REQUEST FOR PROPOSALS

CONSTRUCT HEALTH EDUCATION BUILDING – ELECTRICAL EQUIPMENT

ADDENDUM # 01

The Addendum will form a part of the Contract Documents and modifies the original Bidding Documents dated May 2024.

Refer to drawing E-702Q – ELECTRICAL PANEL SCHEDULES

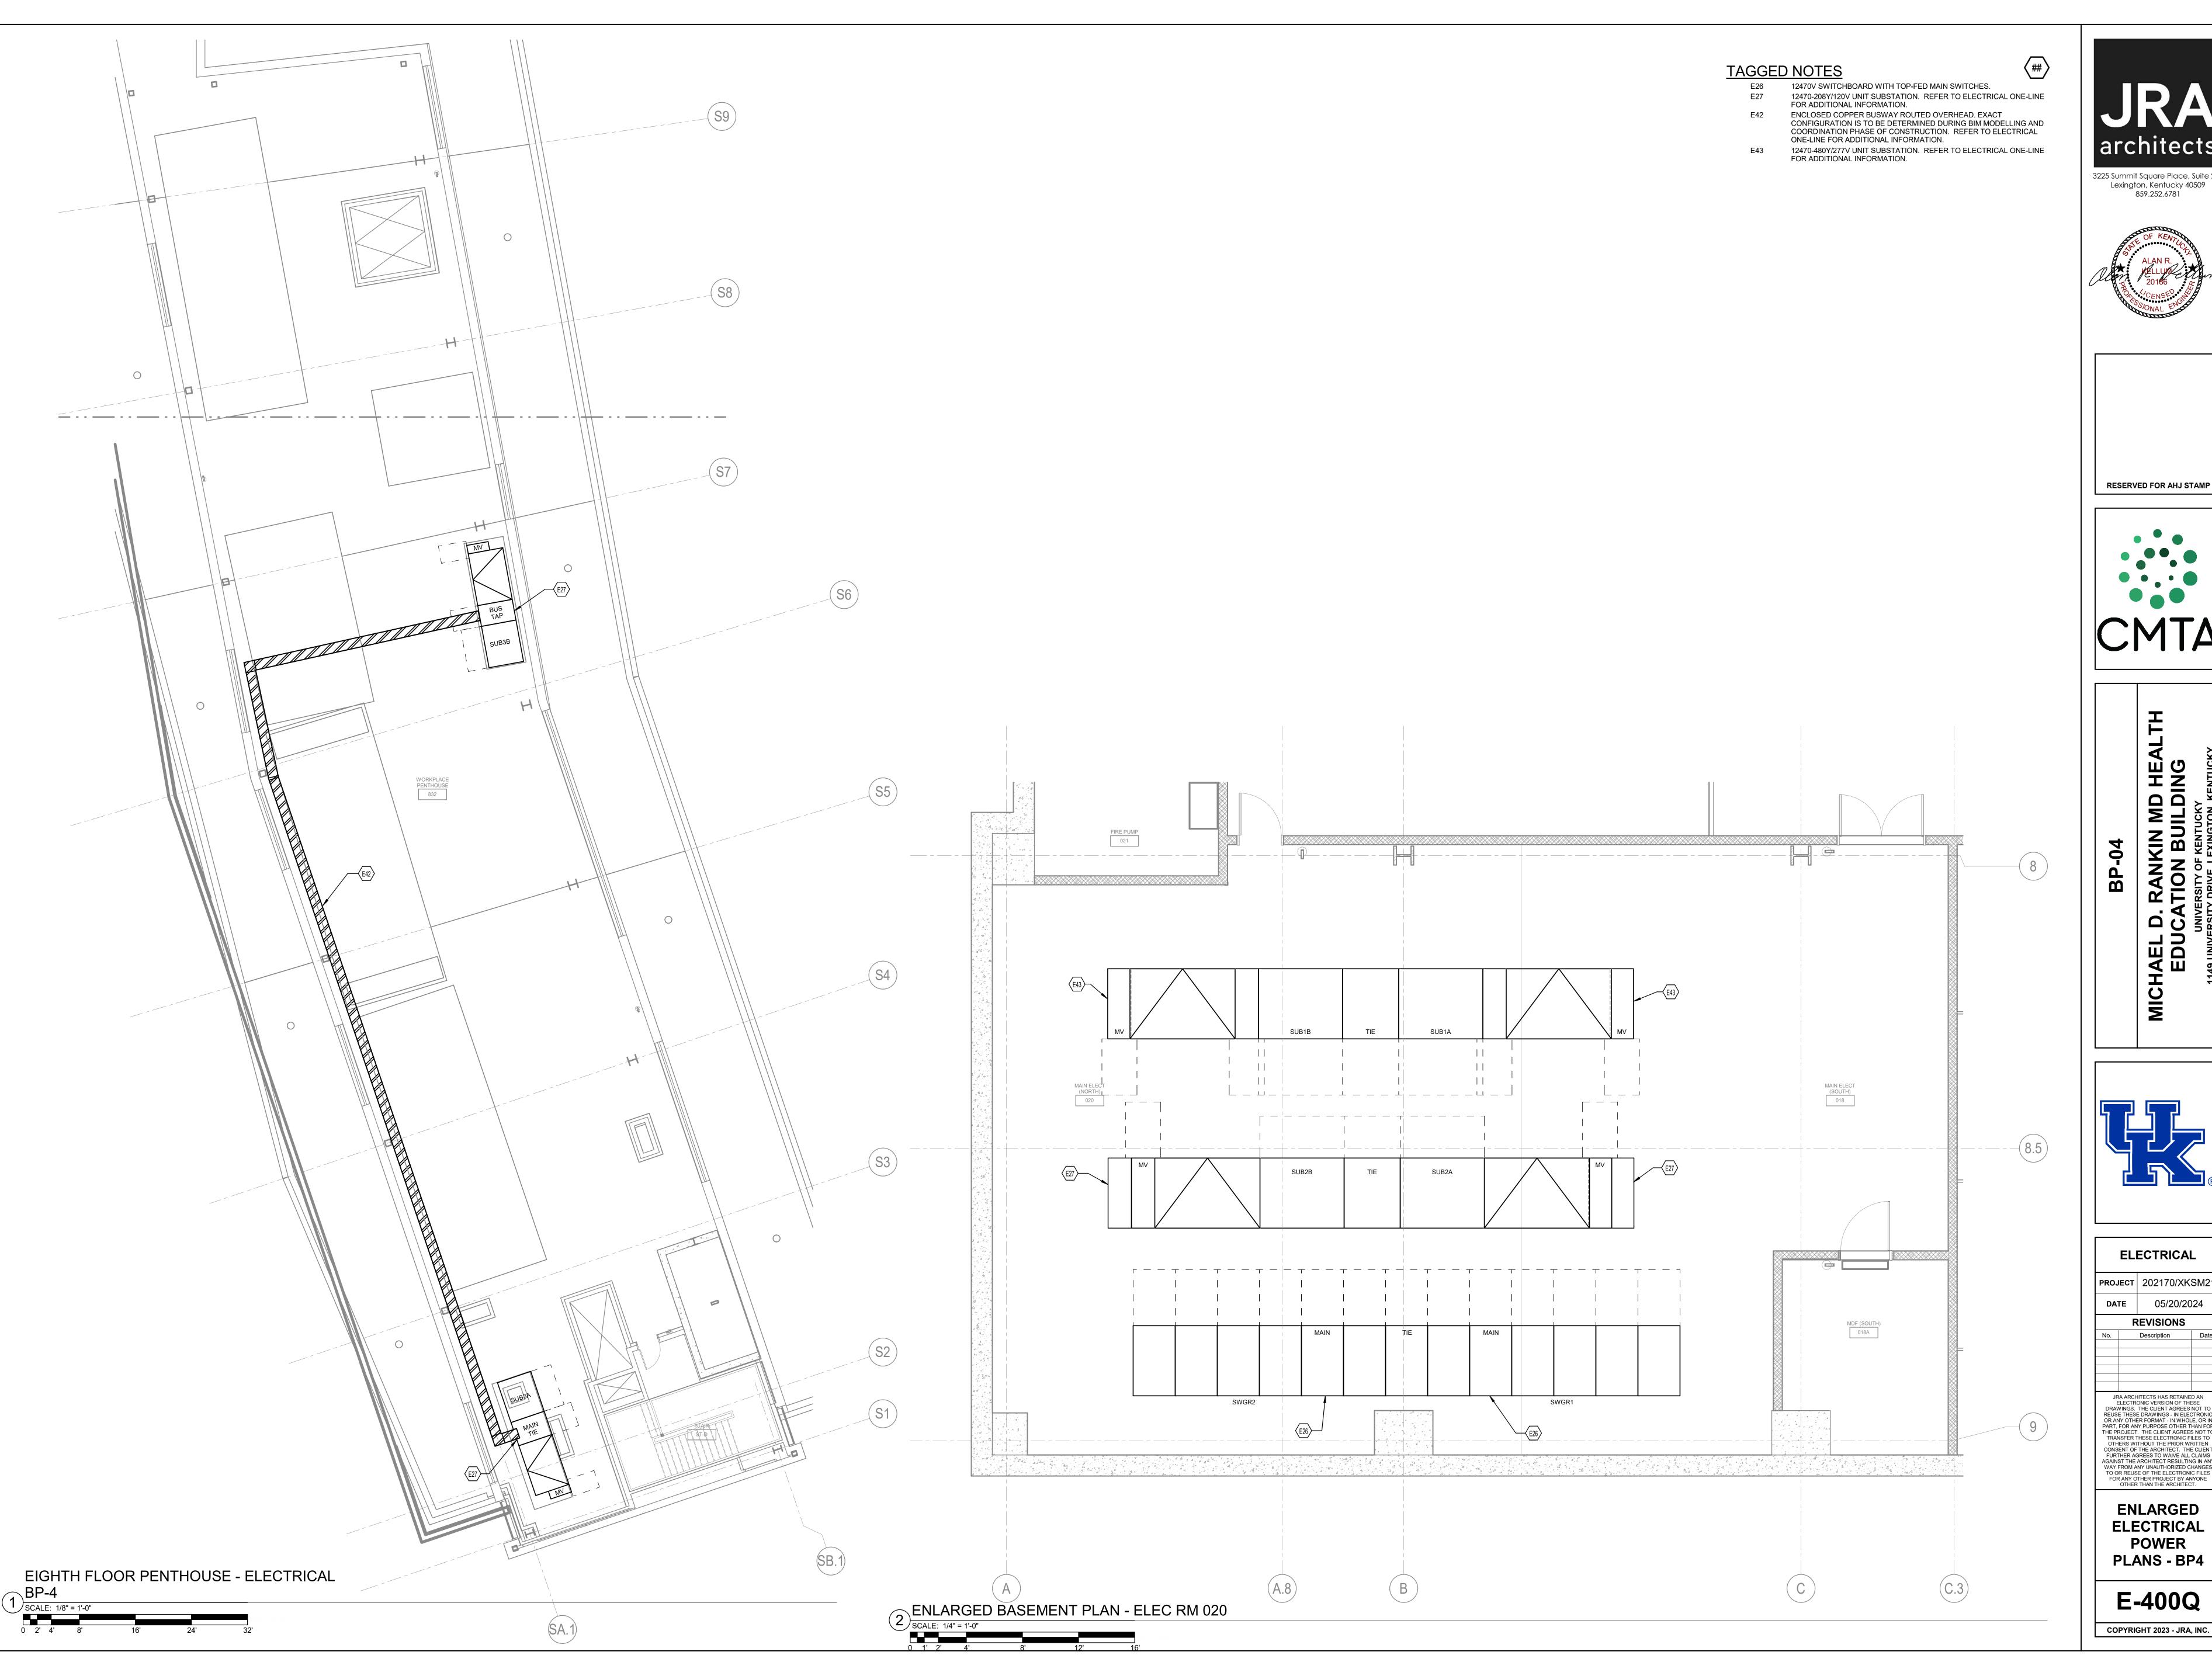
G. Circuit breaker changes have been made to multiple panels on this drawing.

E-601Q - BP-4 ONE-LINE DIAGRAM 1) SCALE: NONE

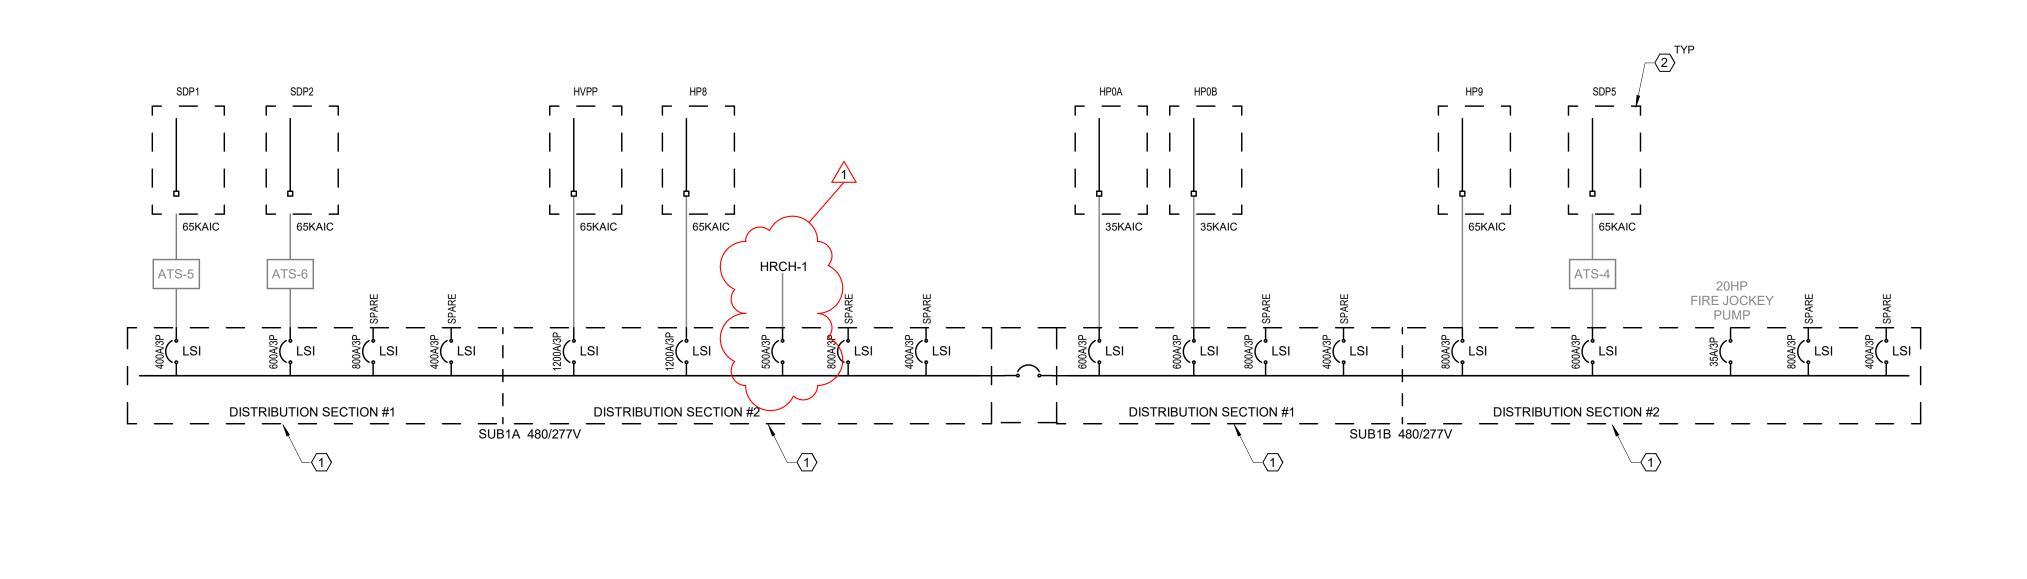
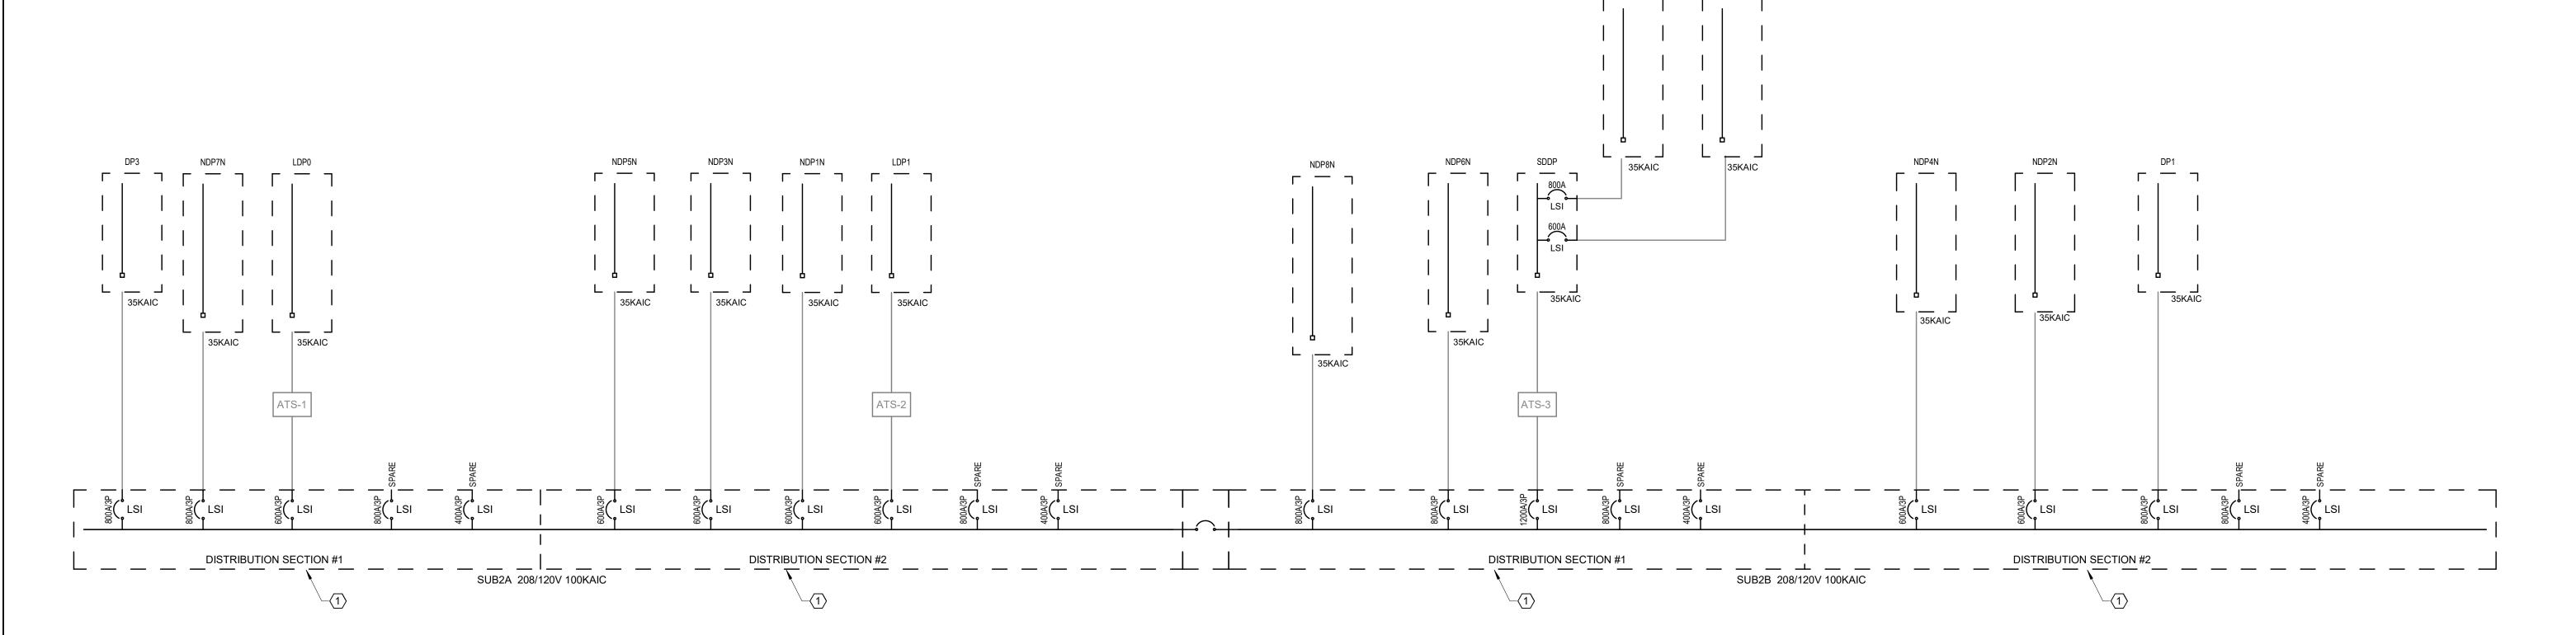
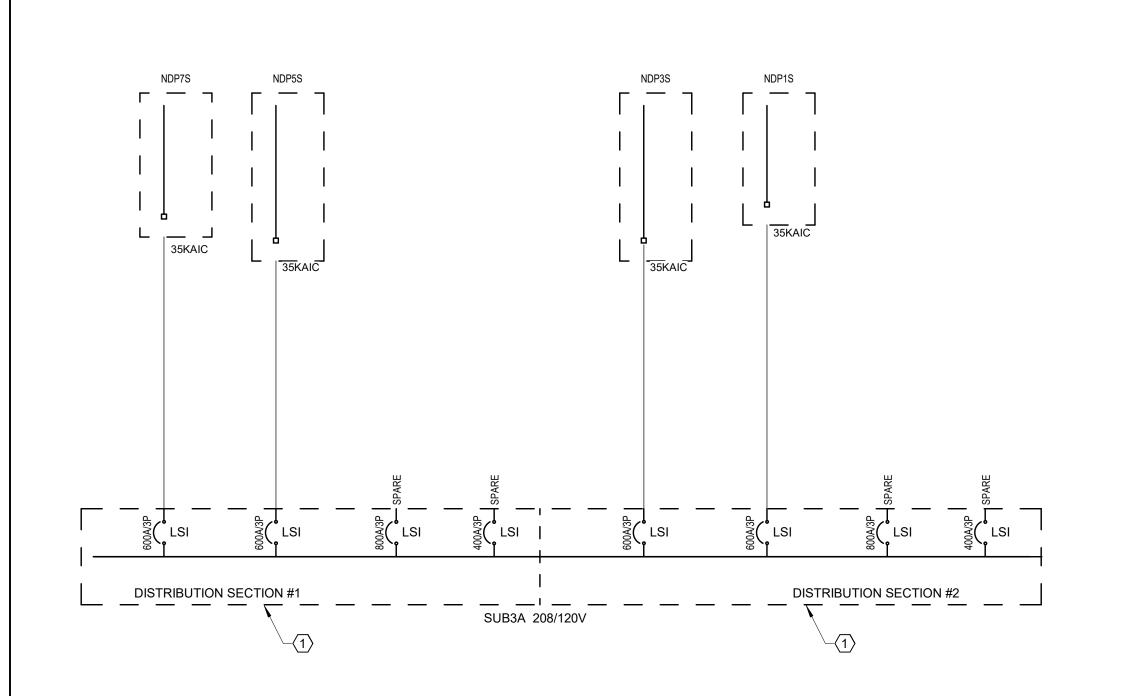
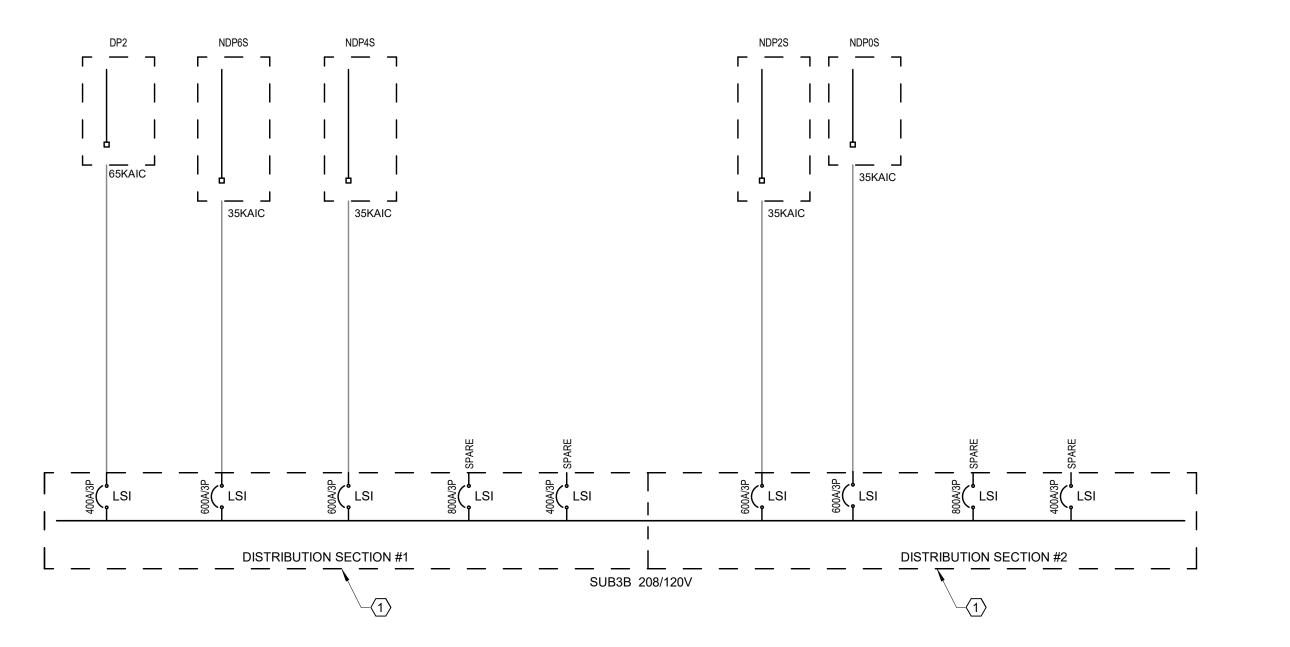
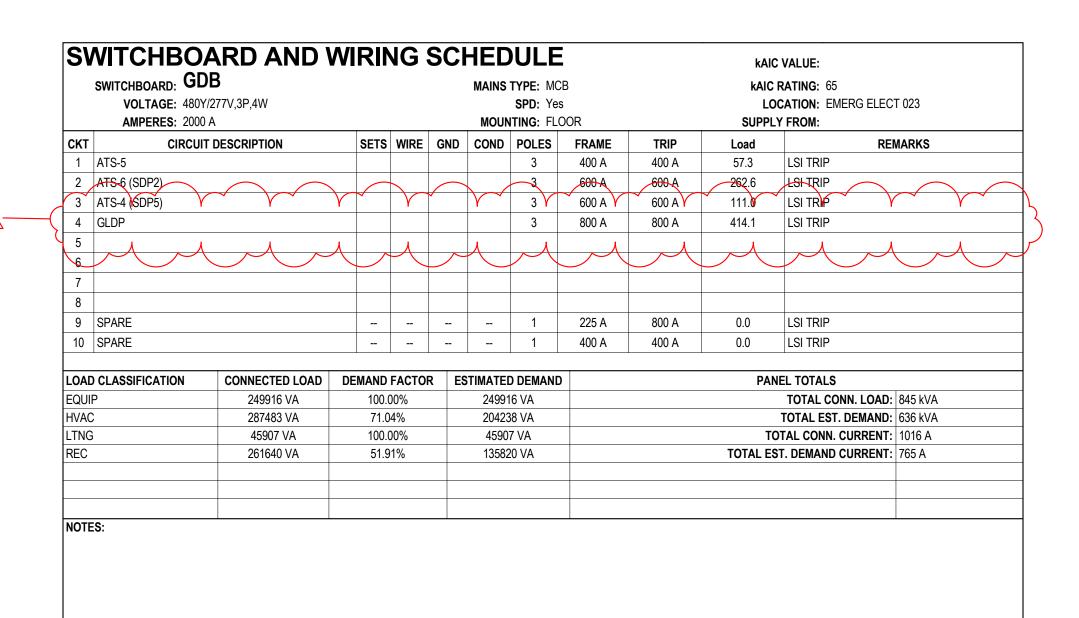
D. Feeder for HRCH-1 has been added to substation SUB1A.
